Tuerk House - Phase-4 RM Sovich Architecture

Item #	RFI#	Name	Date received	Generated by	Dwg / Spec #	Description/question	Conflicting Sheet/ Spec #	Date/ Forwarded to	Date/ Received from	Arch/Engineer Response Date	Arch/ Engineer Response Date	Arch / Engineer Response	Revised drawings/Spec.	Responsibility	Status	ADDENDUM #
1	1	Kim	8/25/23	TBI		Please provide more details on the steps from the penthouse to the roof.						Stair is a non penetrating stair system. Attachment detail if required will be provided once shop drawings are submitted. Refer to specification sheet on section 055000 - non penetrating roof top stair system.		Architect	New Item	ADD#01
2	1	Kim	8/25/23	TBI		2. There is no roof spec. Please provide more detail regarding both roofs.						For the shade roof refer to specification on section 074000. For the canopy roof see the attached spec section 07 53 23 ADHERED EPDM ROOF.		Architect	New Item	ADD#01
3	1	Kim	8/25/23	TBI		3. There are metal guardrails @ Ashburton St main entrance det D6/A2.01, and at stepped seating det B6/A2.5. both are called to be painted. However, ASI-07/5.A calls for stainless steel. Please advise if any railing needs to be field painted.						P

Entrance Trellis
Foundation / Framing Plan
 1/4" = 1'-0"
 1. [Symbol] : INDICATES AREA OF COVERED TRELLIS WITH 1/2"x18GA, TYPE B METAL DECK.

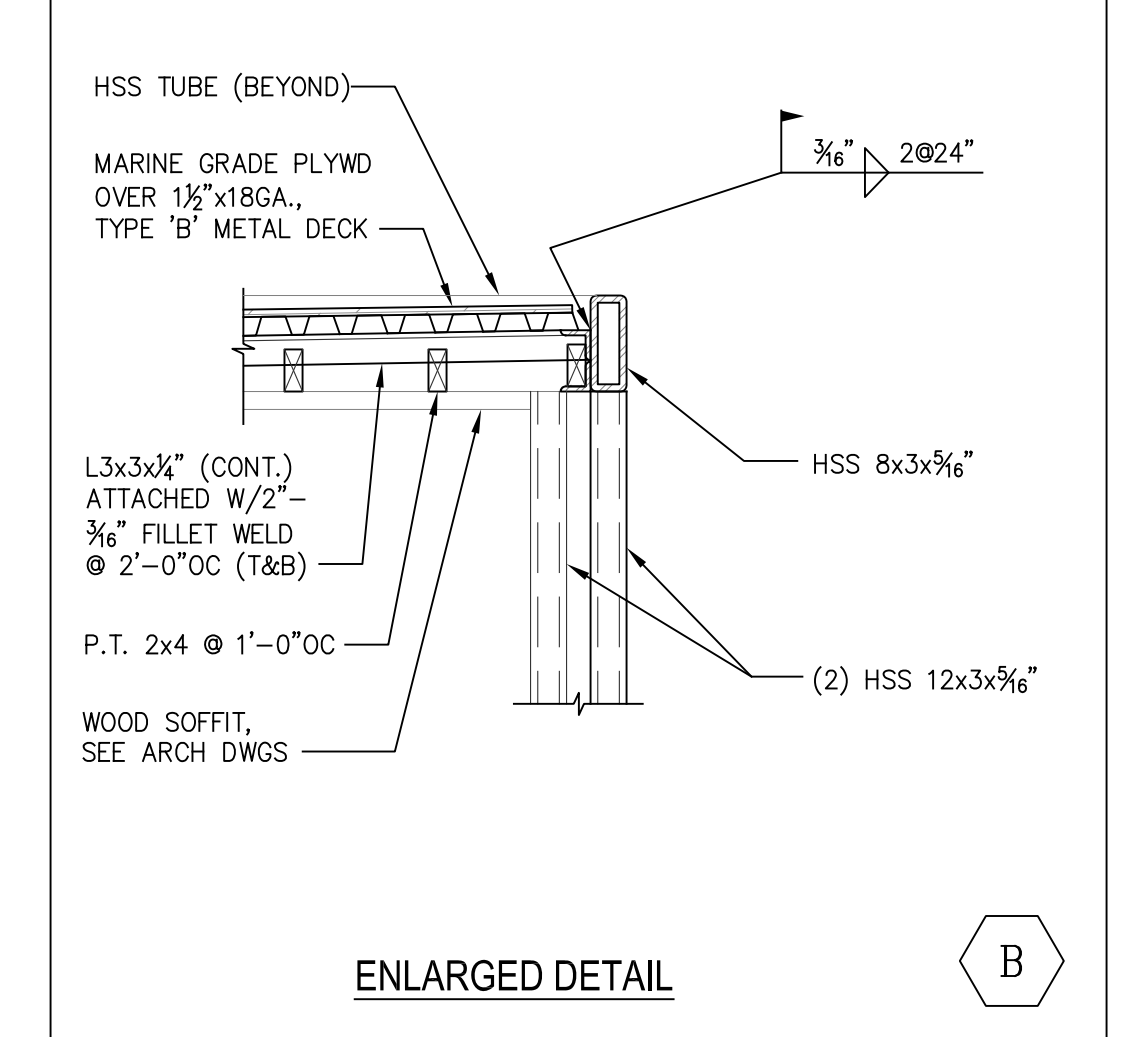
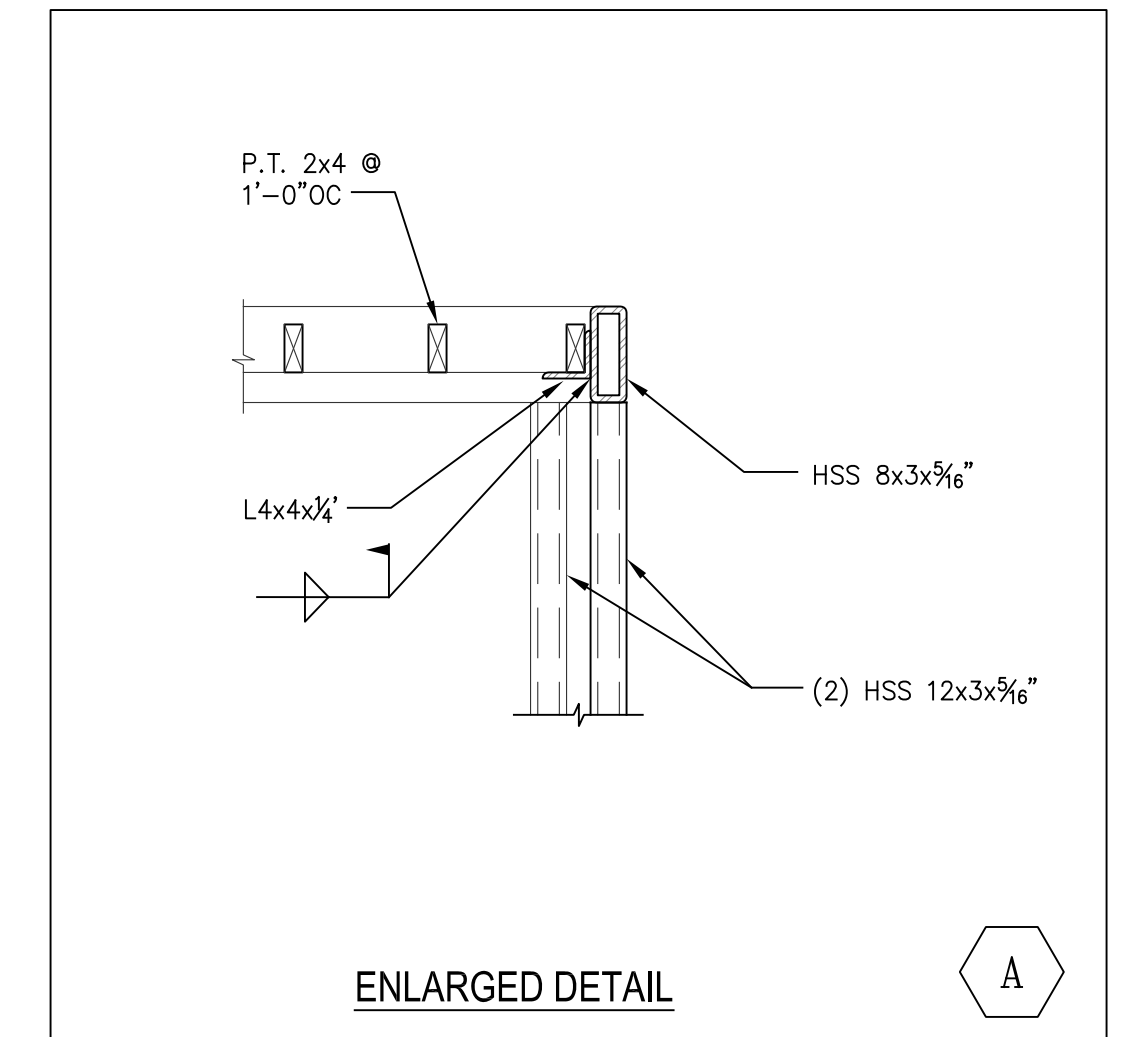
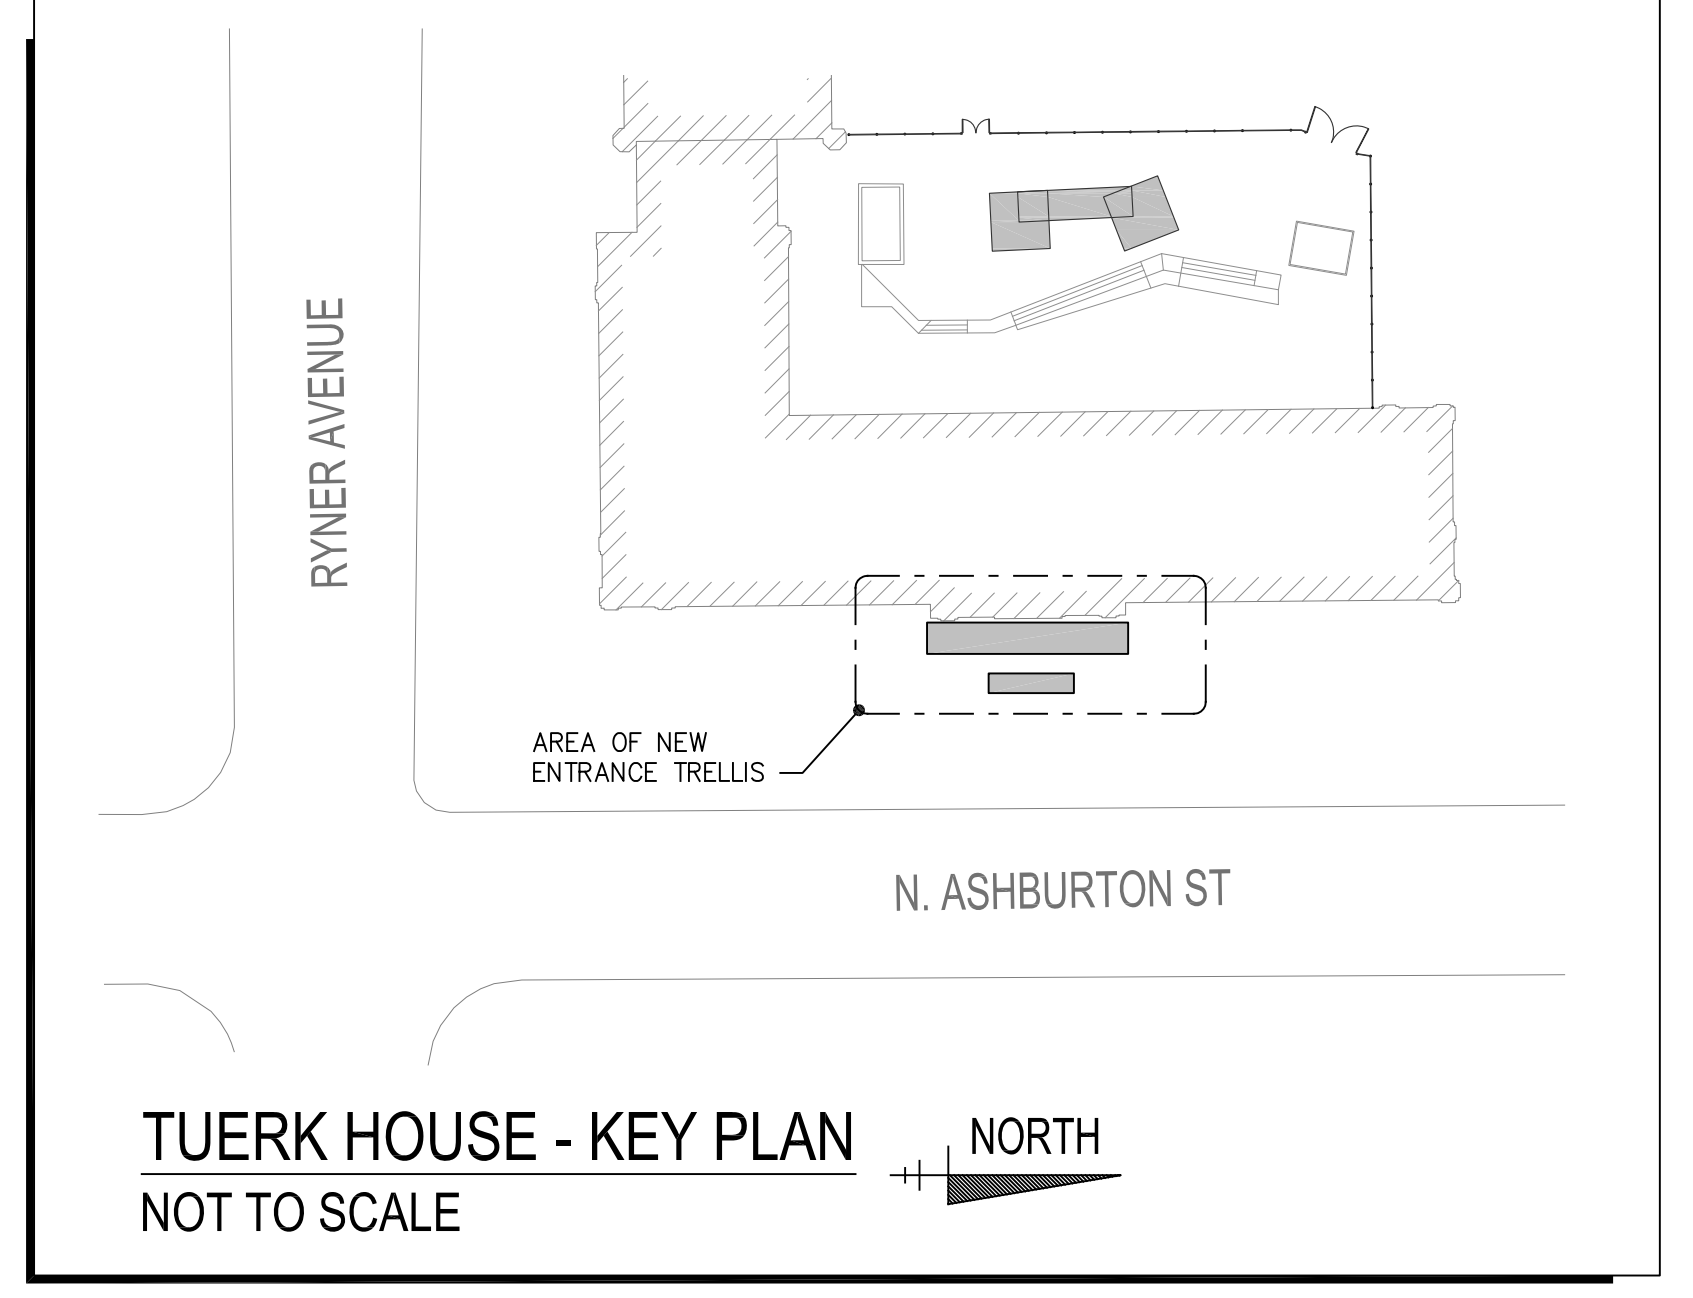
4	1	Kim	8/25/23	TBI		4. Trellis structures, at front & side entrances and rear yard call for clear satin finish on cedar. Please advise what type of finish is to be provided.						Provide clear satin finish.		Architect	New Item	ADD#01
5	1	Kim	8/25/23	TBI		5. The trellis on the front of the building, A2.03 shows the columns and some framing out of steel. I don't see any more detail on the structural drawings about this trellis though as far as steel sizes and elevations. Please advise.		8/25/23 SKA				See the attached Structural drawing S1.05.	S1.05	Structural	New Item	ADD#01
6	1	Kim	8/25/23	TBI		6. Is western red cedar fine for the trellis infill?						Yes.		Architect	New Item	ADD#01
7	1	Kim	8/25/23	TBI		7. I am looking at A2.04 to get an idea of the lengths needed for trellis. B3, far left, looks to be like 5'-3" 2x4's. When I go to section B6 & D2, these same 2x4's appears to be 5'-11". Which drawing is correct. Pictured attached below. Section B6 & D2 show this same trellis below the trellis to the left.						The governing dimension is 12'-6 between centerline of column. The length of 2x4 horizontal frame should be about 12'-1/2". See the attached sketch.	SK-280830-01	Architect	New Item	ADD#01
